MONTGOMERY COUNTY HISTORIC PRESERVATION COMMISSION
STAFF REPORT

| Address: | 7230 Spruce Ave., Takoma Park | Meeting Date: | 5/10/2107 |
| Case Number: | 37/03-17EE | Staff: | Michael Kyne |
| PROPOSAL: | Addition and alterations | | |

*Left Elevation -
Current Proposal*

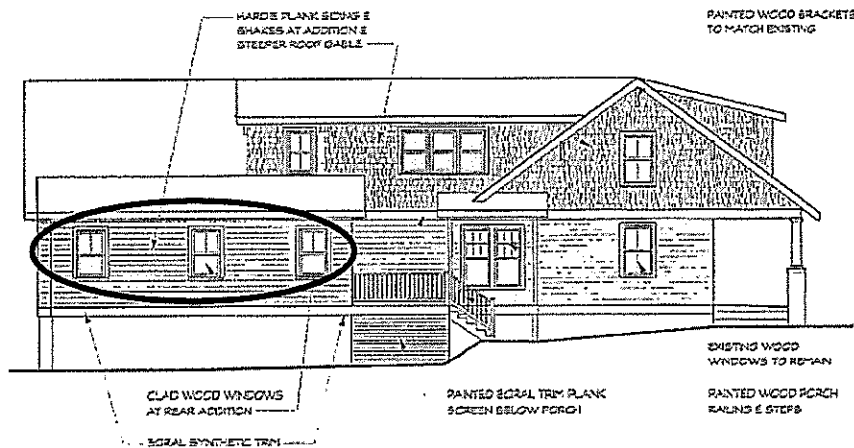
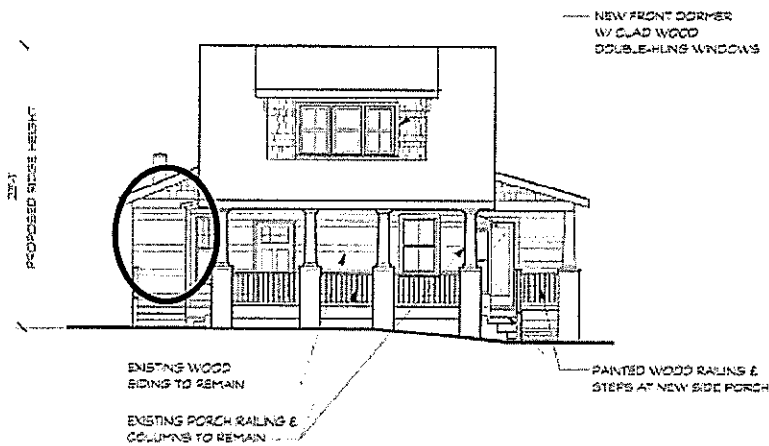
- The applicants previously proposed double-hung windows on the proposed left side addition, while they are currently proposing smaller casement or sliding glass windows.
- In the previous proposal, a door was located on the front elevation of the proposed left side addition. As revised, this door has been relocated to the left elevation of the proposed rear addition.
- A flue pipe is proposed toward the rear of the proposed left side addition's roof.

Staff is supportive of the proposed revisions to the non-historic left side addition, finding that they are generally compatible with the historic house, with minimal potential to detract from the subject property or surrounding historic district.

***Right Elevation -
Current Proposal***

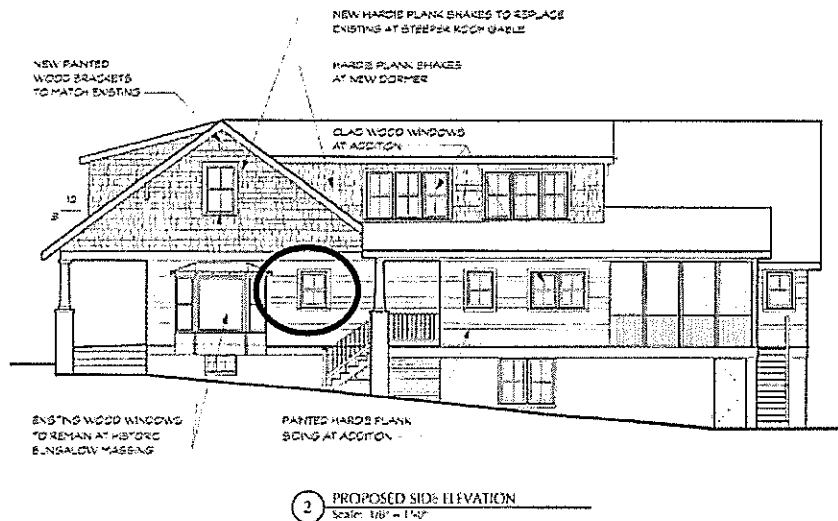
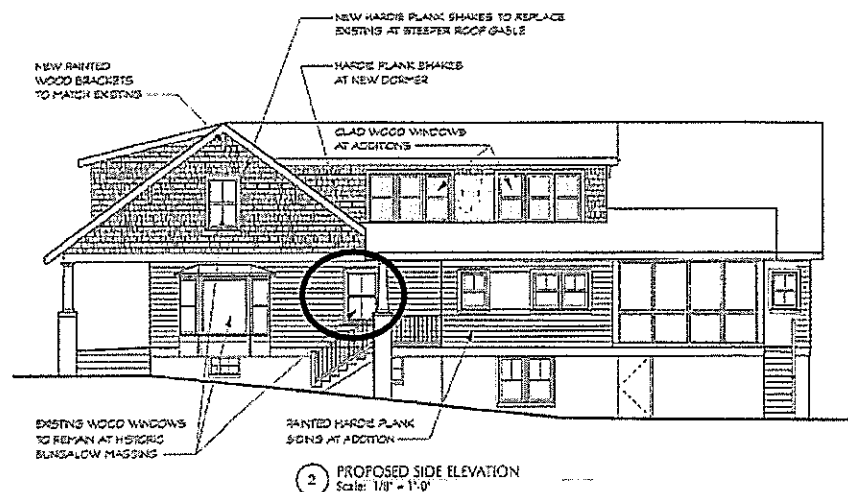
- The applicants propose to remove an original two-over-two double-hung window on the right elevation of the historic house and install a new smaller two-over-two double-hung window closer to the front of the house.

The Commission did not previously review the proposed window removal/installation, and, in accordance with the *Guidelines* – which state “Original size and shape of window and door openings should be maintained, where feasible.” – staff recommends that this aspect of the applicants’ proposal not be approved; however, the proposed work is on a secondary elevation, which is insular and not visible from the public right-of-way, and the Commission may find that it has minimal potential to detract from the subject property or surrounding historic district.

1. Details will be submitted for all proposed windows and doors, with final review and approval delegated to staff.
2. The original window removal/new window installation on the right elevation of the historic house is not approved.

*Left Elevation -
Current Proposal*

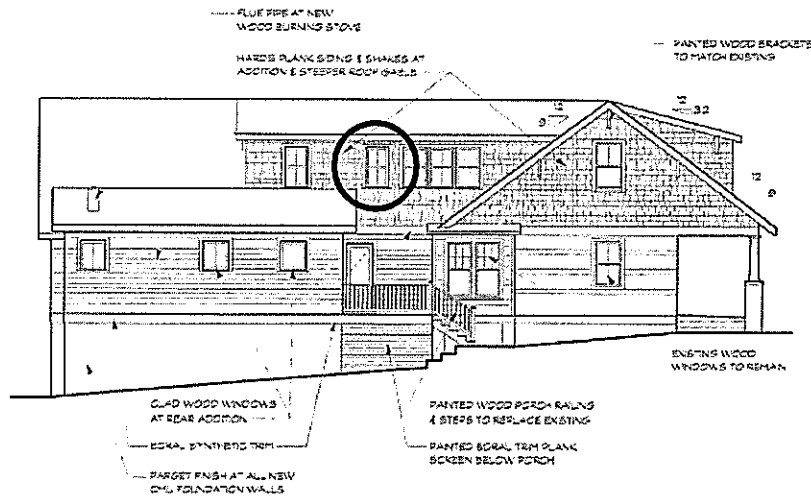
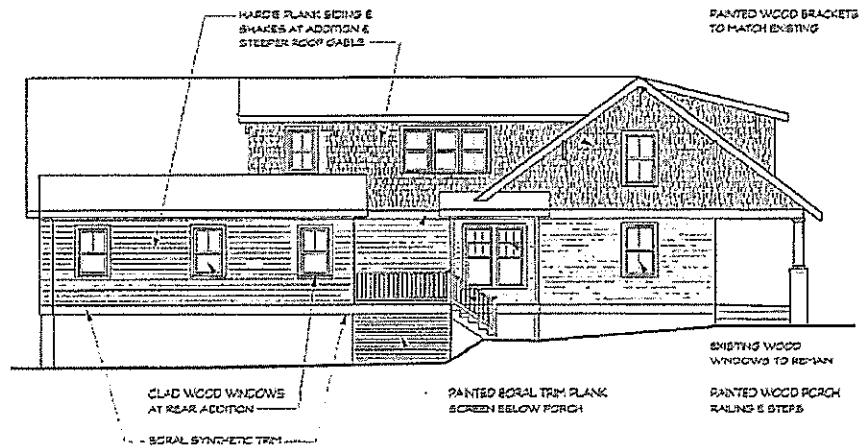
- The applicants propose an additional double-hung window on the second-floor of the left elevation of the proposed rear addition.

The proposed window is consistent with the other windows proposed for the rear addition and is unlikely to detract from the subject property or surrounding historic district.

***Right Elevation -
Current Proposal***

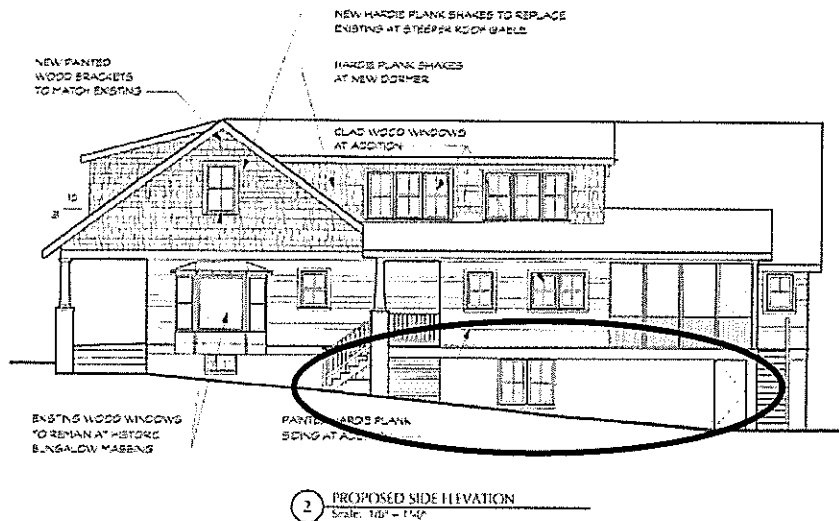
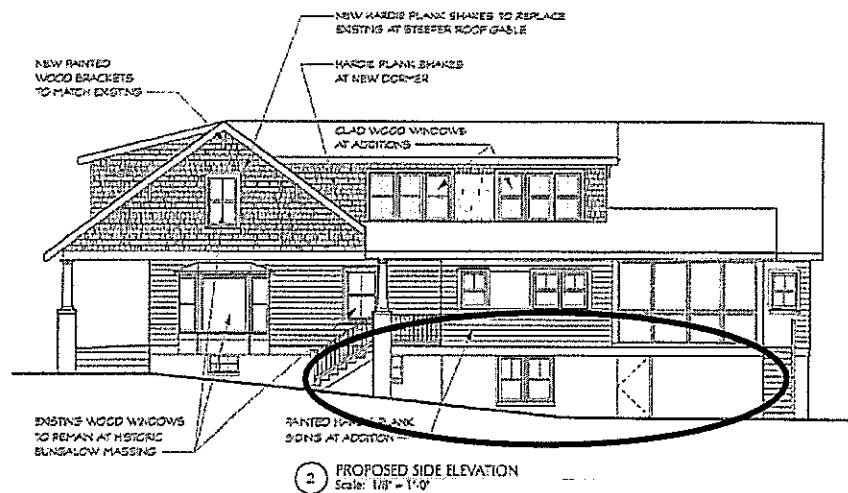
- The fenestration at the basement-level on the right elevation of the proposed rear addition has been slightly reconfigured.

The fenestration to be reconfigured is at the basement-level on a secondary, insular elevation of the proposed rear addition. Due to its location and the property's rear-sloping lot, the fenestration will not be at all visible from the public right-of-way.

***Rear Elevation –
Current Proposal***

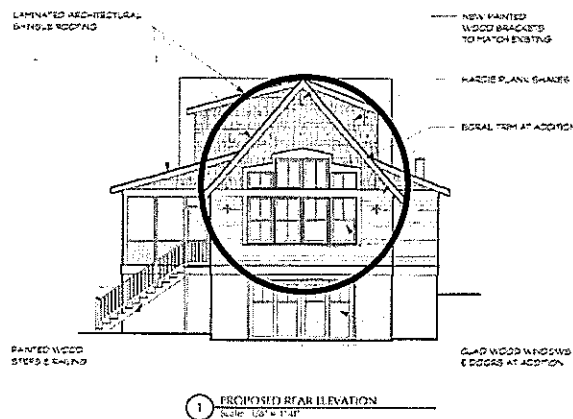
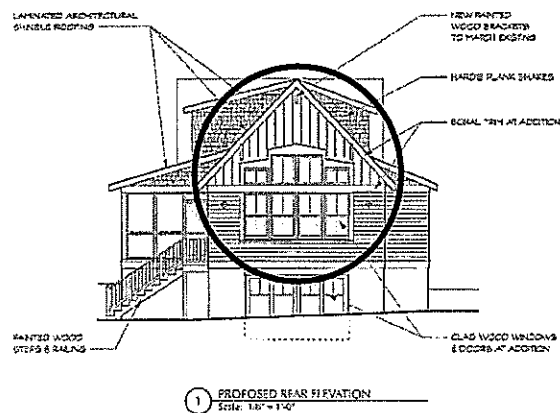
- The applicants have responded to staff and the Commission's suggestion and are proposing Hardie Shakes instead of the previously proposed board and batten in the gable of the proposed rear addition.
